# **JOTRON TB06-2022 AIS with Heating Bracket Instructions**

## FB-40/ Tron 40VDR AIS:

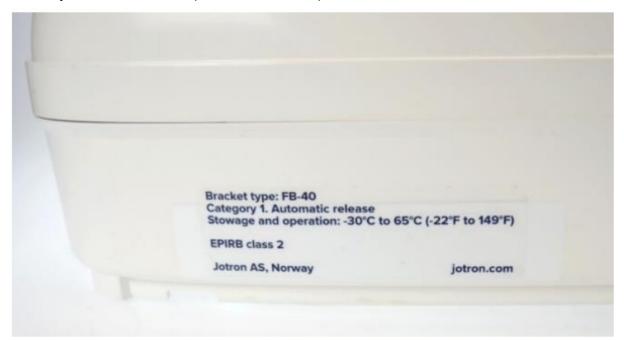
- If any of the above-mentioned spare kits are purchased, the label kit shown above in the center picture shall be used to re-label old FB-40 brackets to correctly show relevant information when Tron 40VDR IS is mounted within. The two bracket pictures on the left side of the label kit above are two variants of brackets delivered with Tron 40VDR, while the two bracket pictures to the right are the same brackets after label kits are mounted. More in detail below.
- · Pictures below show with old labels on left and right hand side of brackets lower part

The old and new labels may look almost the same, but with important difference in new Release tab and procedure on new label.

Before attaching the new labels, clean with Isopropanol / Isopropyl alcohol on all area's labels shall be fitted

• example of cover label fitted (example shows only one, but all three shall be covered)

• and finally fitted with new label (left hand, lower side)

• And fitting the bracket cover label (example shows 2021 version, but same apples to the older ones)
